Bulletin
Number 5037

1948-49 "60" AND "75"
LAND-ROVER

CARBURETTOR

THE ROVER CO. LTD.,
SOLIHULL, BIRMINGHAM, ENGLAND.

Fig. 1

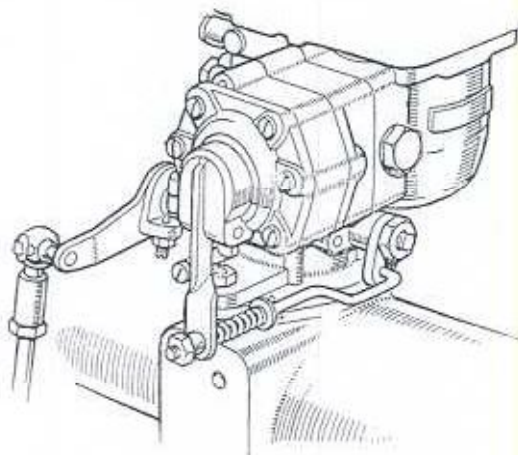
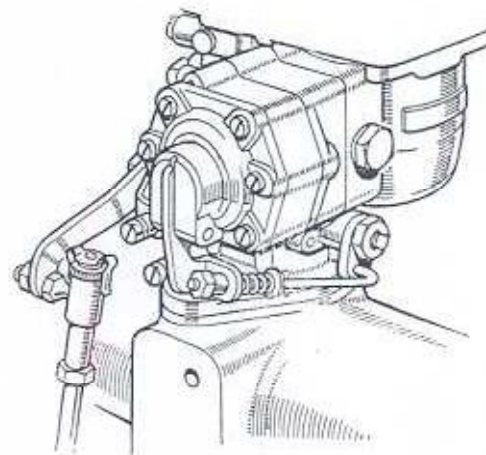
The carburettor accelerator pump on early Land-Rover engines, illustrated at Fig. 1., is so arranged that the pump operates over most of the throttle range.

On such engines, cases have been reported of a weak mixture flat spot occurring during acceleration; this can be eliminated by converting the pump linkage to the latest pattern (Fig. 2), so that the pump operates only during the first stages of throttle opening.

In addition, a main jet size 107.5 should be fitted in place of the original size 102.5 (139 c.c.).

The parts required to carry out this modification are as follows:—

Throttle lever T706, accelerator pump T1562, main jet (107.5) T1563, lever for pump rod T1564 and pump control rod T1565.

Fig. 1. Shield for rear brake pipe.

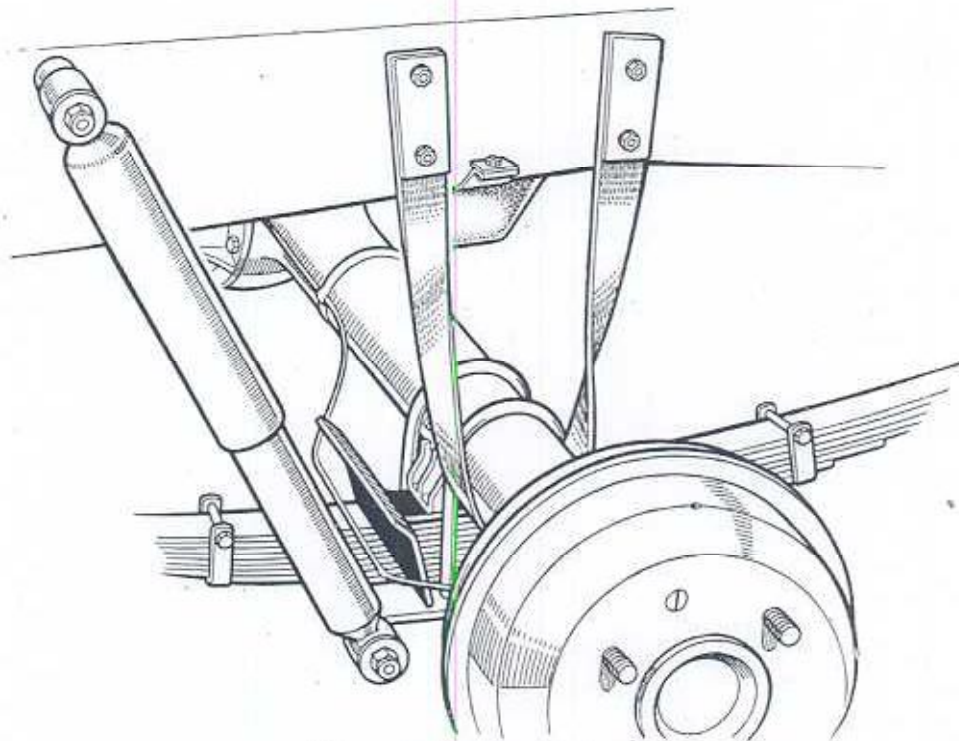
Examine all vehicles in your territory immediately and rectify them as found necessary.

Suitable shields (illustrated in position at Fig. 1) are obtainable free of charge from our Spares Department, the part numbers being L.H. 232089 and R.H. 232088.

Fig. 1

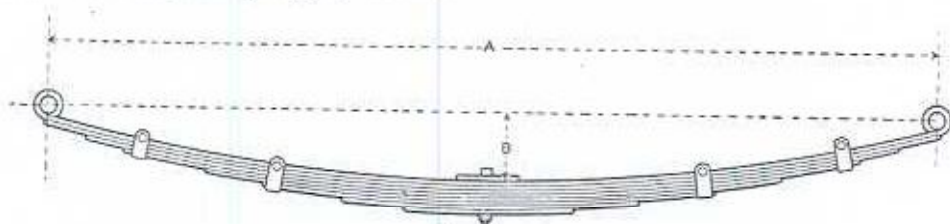
Several changes have been made in the design of Land-Rover road springs; details of these alterations are set out below to assist in the correct maintenance and replacement ordering for the vehicles concerned.

The **FREE CAMBER** of the spring, when removed from the vehicle, is used as an identification feature. It is indicated by the measurement "B" at Fig. 1, i.e. the distance from the top of the main leaf to the line joining the spring eye centres.

Should operating conditions warrant the modification, the original 8 leaf springs (Types 1 and 2) can be converted to the Service 9 leaf pattern by the addition of
